# Product Change Notification

## TE Connectivity

**Product Change Notification:** PCN-22-152896

**General Product Description:** (Text limited to 120 characters)  
T9S, T9V series relay

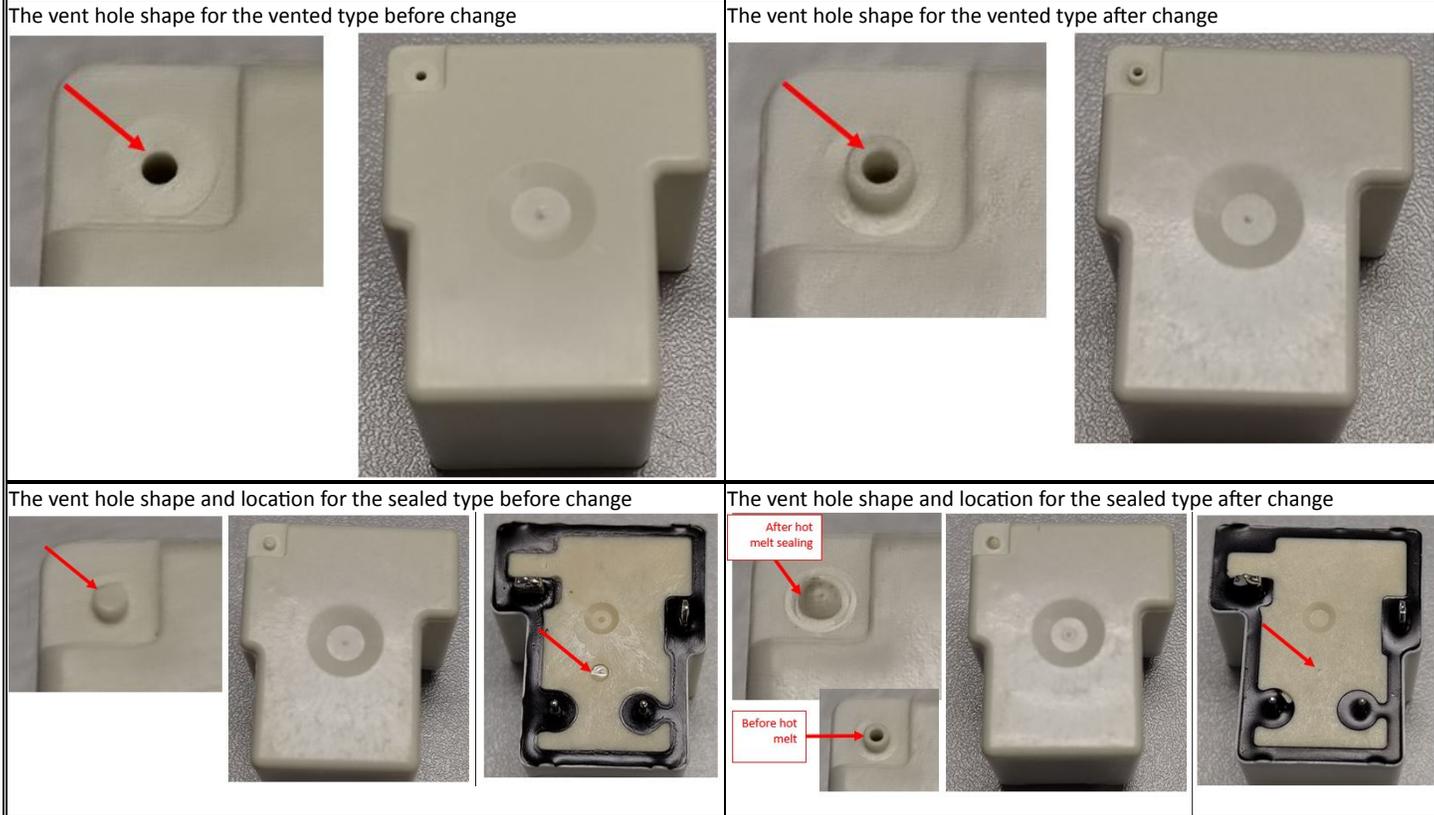
**Description of Changes**  
Dear customers, please be aware of an upcoming feature change to the listed T9S/T9V part numbers with the new melted sealing technology, there is no impact on the product performance with the change. You can see comparison details in the below PCN images table. Before: 1. for the sealed type, it's a sealed nib vent hole on the cover, and use UV glue to seal the bent hole on the base finally. 2. for the vented type, it's flatness around the vent hole on the cover. After: 1. for the sealed type, use melting sealing technology to seal the vent hole on the cover finally, not use UV glue further and cancel the vent hole on the base. 2. for the vented type, it's a opened nib vent hole.

**Reason for Changes:**  
New melted sealing technology implementation to cancel UV glue usage.
